ADDISON AIRPORT BUILDING REPORT					
Facility Information:	Facility Name: 4540 Glenn Curt	tiss Drive			
Facility Contact: Lisa Pyles	Contact Phone: 972-450-2878				
Accessology Inspector Information:					
Inspector: Karen Jackson Email: Kjackson@accessology.com		e: April 17, 2017			
Latitude: 32.969853	Longitude: -96.831465				
Address: 4540 Glenn Curtiss Drive	City: Addison	County: Dallas			
General Parking Notes: There is no parking associat Total Parking Spaces: Total Accessible Parking Spaces: Number of van accessible spaces: Is the accessible parking substantially compliant?		N/A N/A N/A N/A			
Parking Violations Total \$0	High Priority Medium Priority Low Priority	1-4 y 5-8 9-12

ADDISON AIRPORT - 4540 Glenn Curtiss Drive Entrance - Page 2
Text:	Handles, pulls, latches, locks, and other operable parts on doors and gates shall comply with 309.4.
Possible Solutions:	Provide accessible door hardware.
Violation #2 Cost:	\$525 Priority Level 4
	High Priority 1-4
Entrance Total	\$3,150 Medium Priority 5-8
	Low Priority 9-12

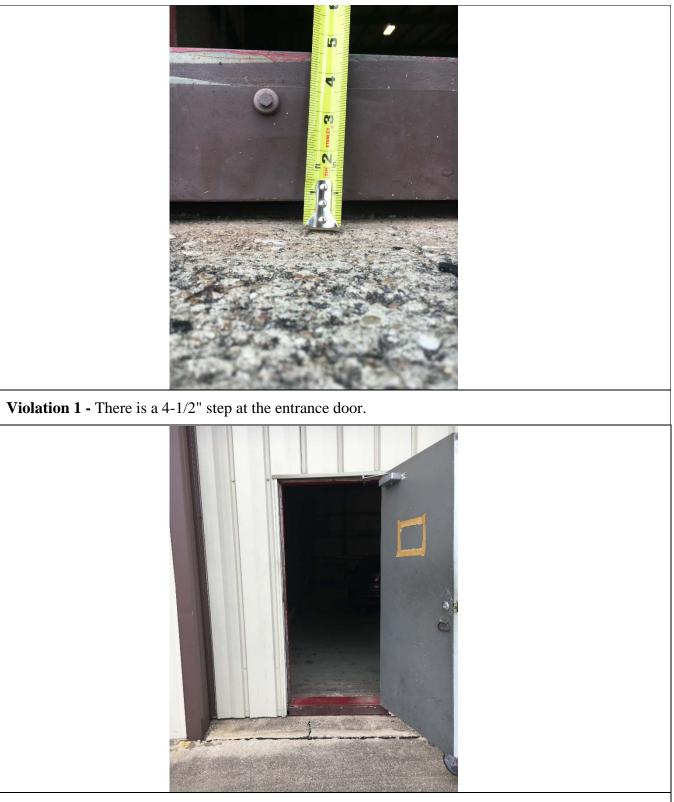
Violation #1 Cost:	\$2,625	Priority Level 3			
Violation #2:	ne door hardware/lock provi perate.	ded at the entrance requires grasping	and twisting to		
Standard:	2010 ADAAG 404.2.7	7 Door and Gate Hardware.
